Product Change Notification

Date Issued: March 14, 2022 PCN Number: 511552 Reason for Change: Capacity change or tool replacement Description of Change: This notification is to inform you about set of tooling is being added to meet the current and future demands of this product referenced below. There will be no changes in fit, form or function from additional tooling when compared to the existing tooling Reason for Short Notice: Capacity Increase Assessment of Change: First Article Inspection Planned Implementation Date: April 30, 2022 Sample Availability Date: March 30, 2022

Before Picture

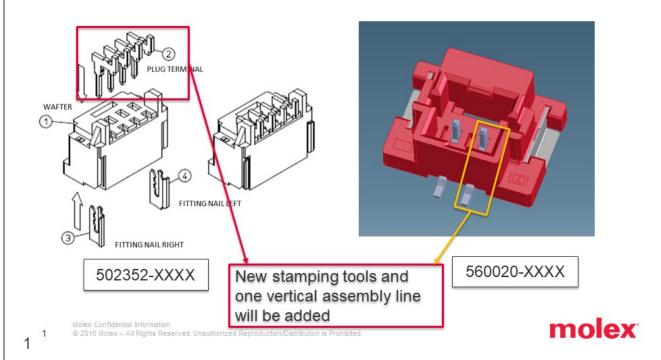
- To support increased demand, new stamping tools of Dura-click 502352, 560020 series and one vertical assembly line of Dura-click 560020 series are being fabricated to increase capacity.
- Product Impact
 - no impact to fit, form or function
- Part Number Impact
